**INDEPENDENT EXPERT  
ADVISORY PANEL FOR MINING**

**HUNTER VALLEY OPERATIONS  
CONTINUATION PROJECT  
(SSD-11826681 and 11826621)**

**July 2024**

**Advice No: IEAPM 202407-2**

Figure 2: Plot showing breakdown of predicted GHG emissions and intensity factors (Figure 4.1 of HVOPL’s Submissions Report (EMM, 2023)).

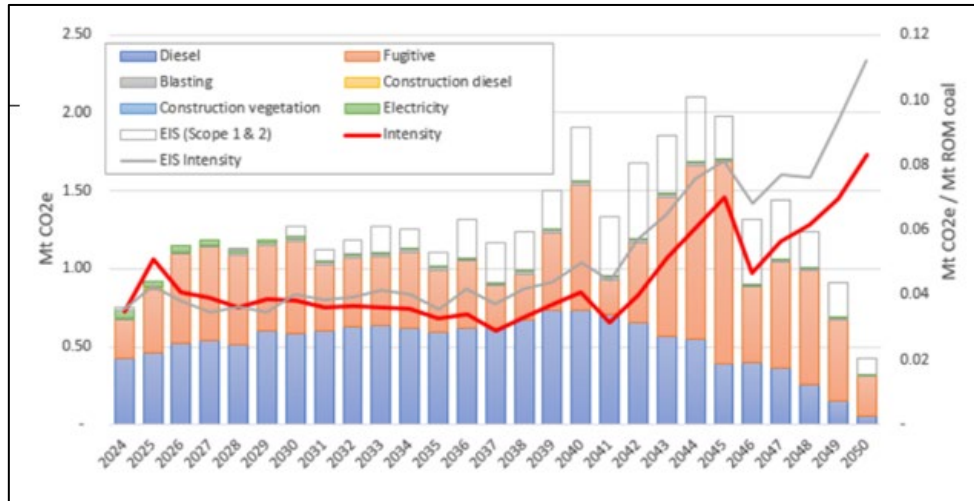
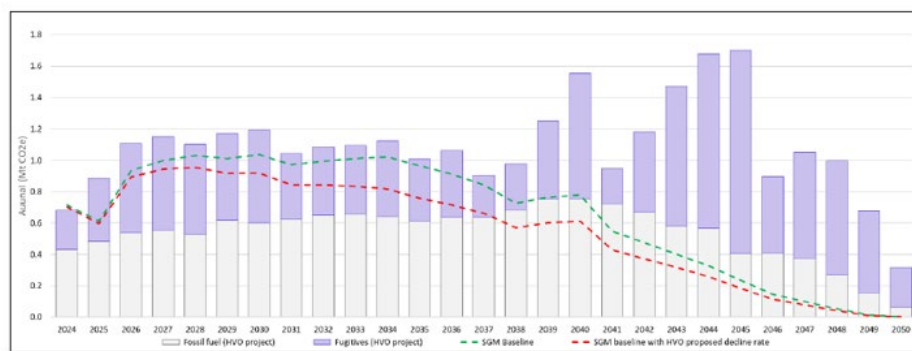
8. From 2042 to 2050, there is over a 200% increase in the emissions intensity factor, notwithstanding that ROM production and associated diesel fuel emissions taper off to zero (Figure 2).

Avoidance of fossil fuel emissions at HVO is dominated by a focus on measures to reduce and/or transition away from the consumption of diesel fuel. Figure 3 shows a steady rise in diesel emissions to 2040, followed by a steady decline until the end of the Continuation Project in 2050. Diesel emissions account for approximately 50% of Scope 1 and Scope 2 emissions at HVO over the proposed Project life and for ~60% of these emissions up to 2040. Stationary and off-road equipment account for approximately 98% of diesel emissions each year of operation, with the trend in emissions correlating reasonably well with ROM production, which is not unexpected. The principal contributors to the diesel GHG emissions are dump trucks, which number about 90 and have gross weights of 400 to 500 t, depending on whether they haul coal or overburden.

Figure 6 ROM coal production over the life of the Continuation Project (Figure 4.13 of *Submissions Report* - (EMM, 2023))

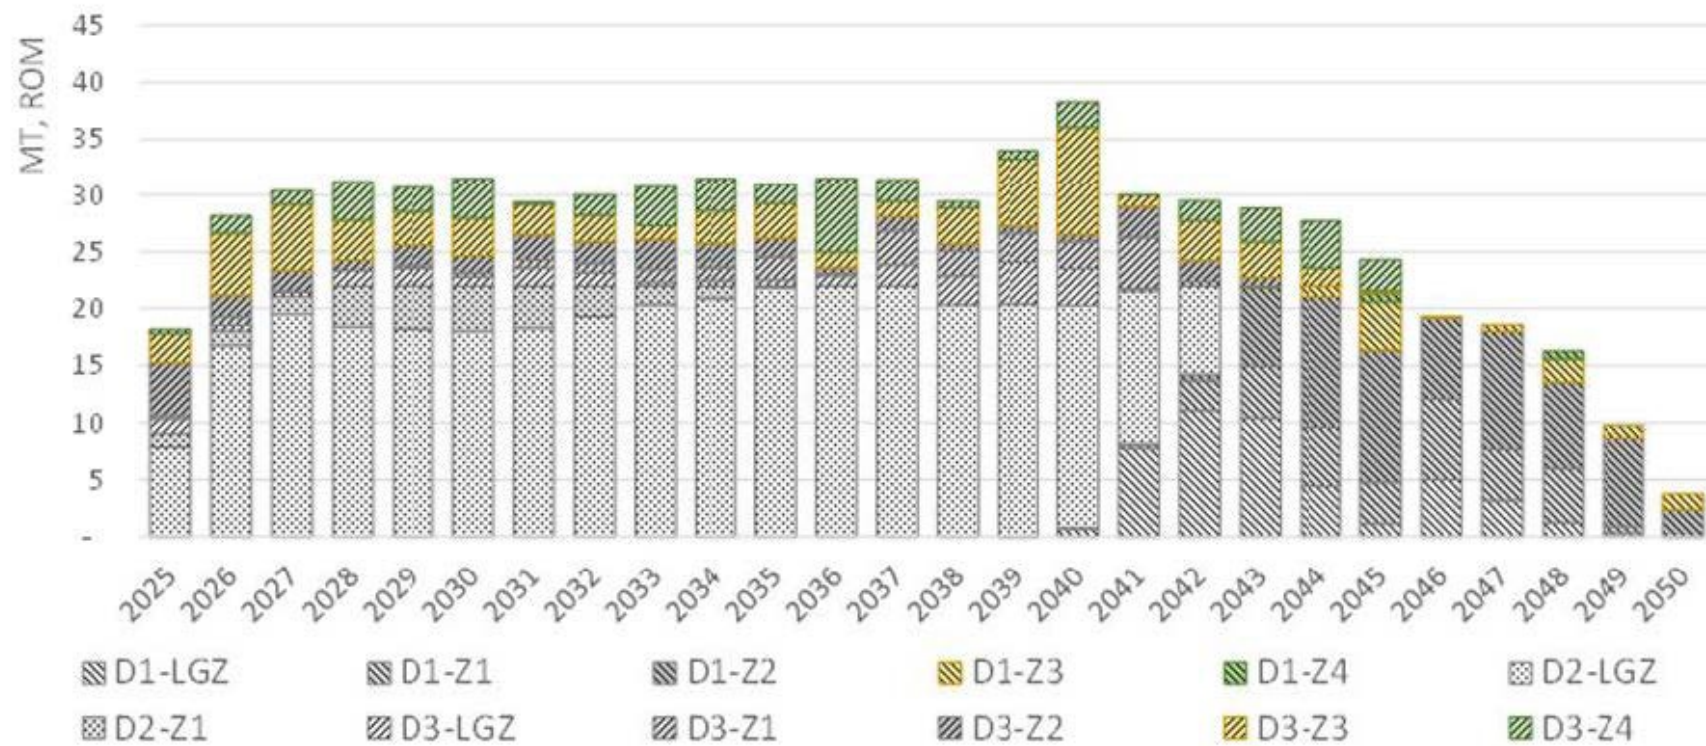
On the basis of the breakdown of sources of annual production and annual fugitive emissions displayed in Figure 6 and Figure 7, the Panel concludes that:

1. The only fugitive emissions avoidance measure available is mine planning that restricts the areal extent of mining and/or the depth of mining.
2. A significant fugitive emissions avoidance measure at HVO would be not to mine Zones 2, 3 and 4 in Domain 1.

Figure 7: Breakdown of fugitive emissions by Domain (D) and Zone (Z) over the life of the Continuation Project (Figure 4.14 of *Submissions Report - (EMM, 2023)*)

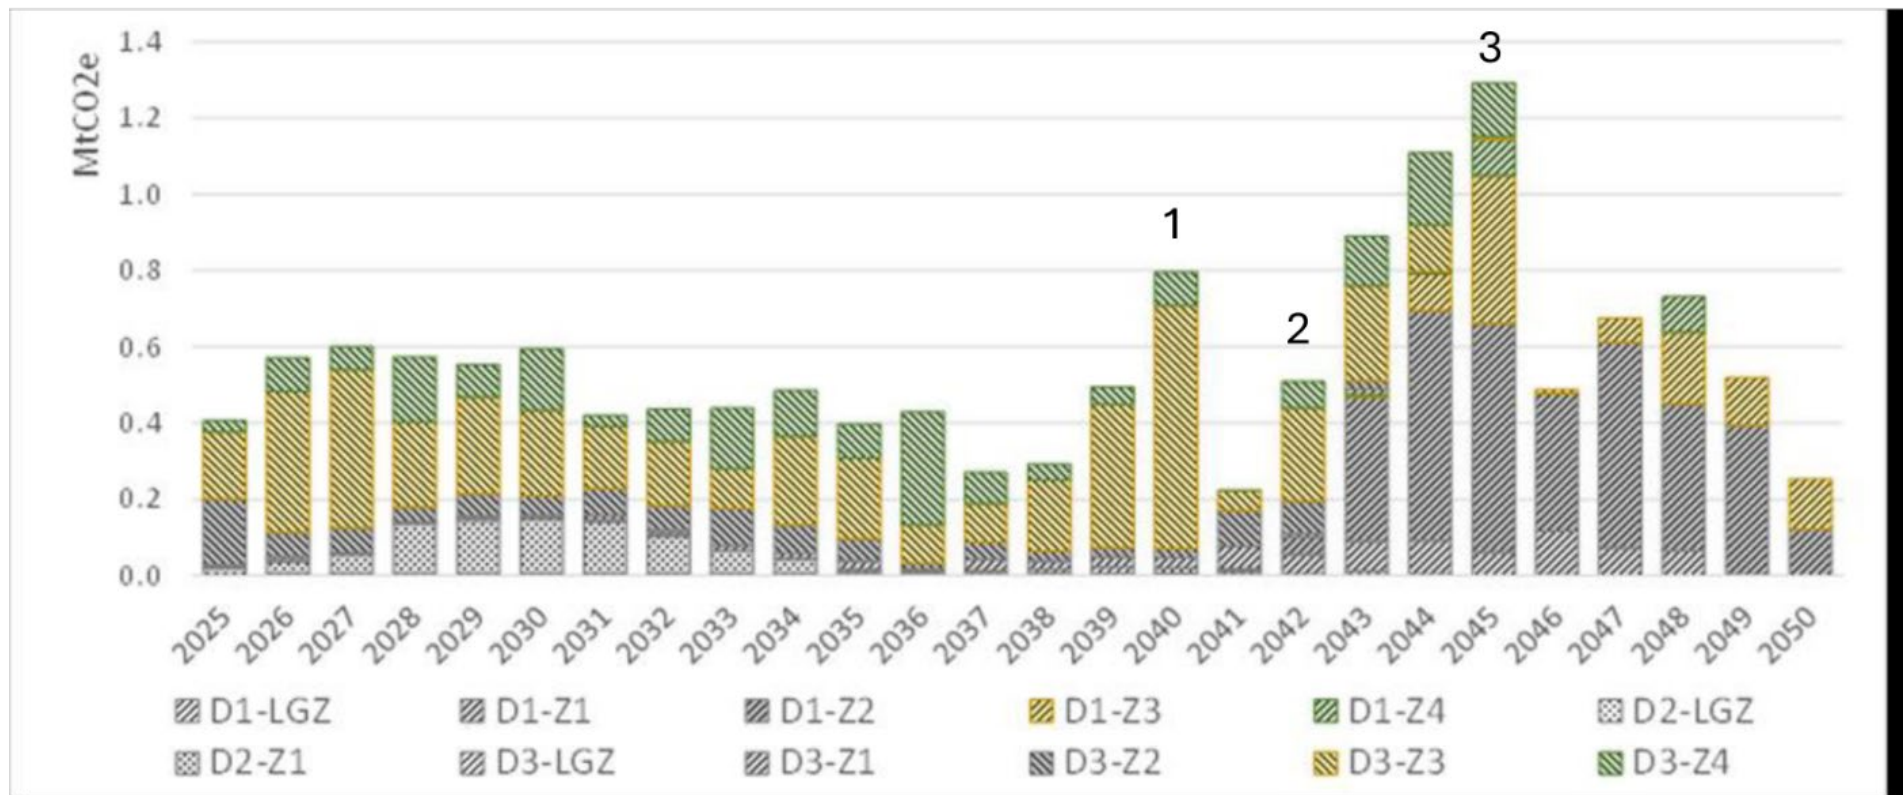
The projected spike in emissions in 2040, labelled '1' in Figure 7, corresponds to predicted ROM coal production peaking that year and to an increased ratio of deeper seams being mined in HVO\_South. These deeper seams are associated with higher gas contents in Domain 3 as shown in Table 3.

The projected spike in emissions in 2042, labelled '2' in Figure 7, corresponds to when mining in HVO North starts to progress into the methane dominated seams in Domain 1. By 2045, all mining in HVO North is scheduled to occur in Domain 1, accounting for the spike in fugitive emissions, labelled '3'. Here there is both an increase in emissions in Zones 3 and 4 and significant emissions from the less gassy Zone 2.

1. Zones 2, 3 and 4 in Domain 1 all contain significant proportions of CH<sub>4</sub> (Table 3).
2. Zone 2 has a low gas content (2.5 m<sup>3</sup>/t, Table 3) but a high gas volume (Figure 7).

3. Due its low gas content of 2.5 m<sup>3</sup>/t, it is unlikely that Zone 2 is suitable for pre-drainage.
4. Zone 3 and Zone 4 have high gas contents (6.1 m<sup>3</sup>/t and 4.4 m<sup>3</sup>/t, respectively, Table 3) but each zone contains typically less than half the gas emissions of Zone 2 (Figure 7).

5. Zone 3 and Zone 4 have potential for gas-drainage (discussed in more detail in Section 4.2.7).
6. From 2043 forward, Zone 2 accounts for at least 50% of annual CO<sub>2</sub>-e fugitive emissions (Figure 7).

7. From 2043 forward, the annual CO<sub>2</sub>-e fugitive emissions from Zone 2 alone are of a similar magnitude to annual CO<sub>2</sub>-e fugitive emissions of the Continuation Project up to that point in time (Figure 7).

Based on Figure 7, the Panel has calculated that 30% to 50% pre-drainage of Zones 3 and 4 in Domain 3 would result in a reduction of GHG emissions to the atmosphere of 17% to 34%, assuming complete combustion of  $\text{CH}_4$  if implemented successfully from the start of the Continuation Project.

3. If Zones 2, 3 and 4 in Domain 1 were not to be mined and the current mine plan was not to be revised, mining would effectively cease at the end by 2044, some 6 years earlier than planned. However, it is possible that mining may cease before that date due to the impacts and consequences of such a decision on the viability of mining just Zone 1.

4. If Zones 2, 3 and 4 in Domain 1 were not to be mined, a revised mine plan may result in the remaining mining in Domain 3 being completed earlier than 2044.

5. If consideration is to be given to these types of options, the options should be put through a mine planning process in order to verify the merits and impacts of the options and properly inform decision making.
